Office Action Summary	Application No. 10/693,355	Applicant(s) DWYER ET AL.	
	Examiner Melissa J. Koval	Art Unit 2851

DETAILED ACTION

Claims 1-12, 14, 16, 19-27, 29, 31-37, 39, 40, 42, 43, 46, 47, 49-51, 54, and 57-68 are rejected under 35 U.S.C. 103(a) as being unpatentable over Derryberry (U.S. Patent 6,626,543 B1).

Fig. 4

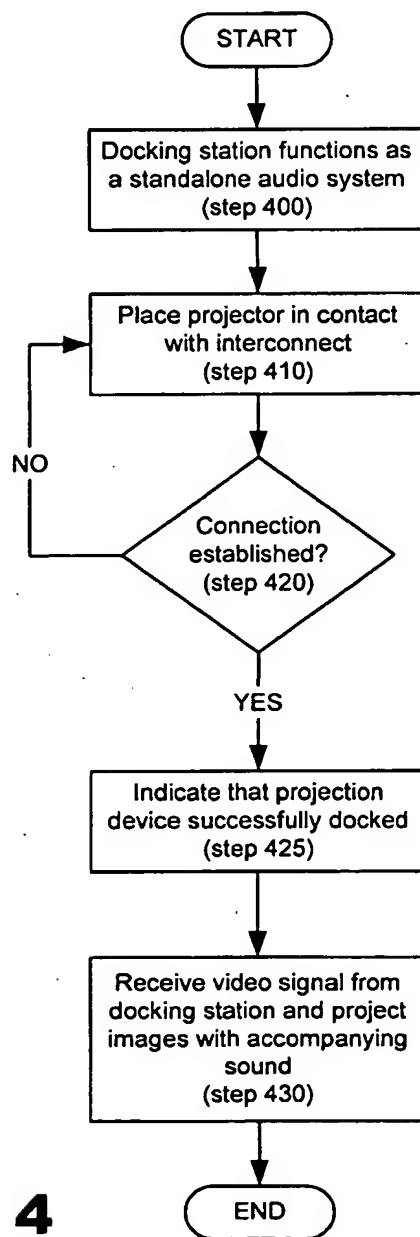
Applicant further proposes to amend Fig. 4, as shown below, to add step 425 "Indicate that projection device successfully docked" and to change step 430 to add the indicated language: "Receive video signal from docking station and project images with accompanying sound (step 430)." A replacement sheet bearing the amended Fig. 4 is also filed herewith.
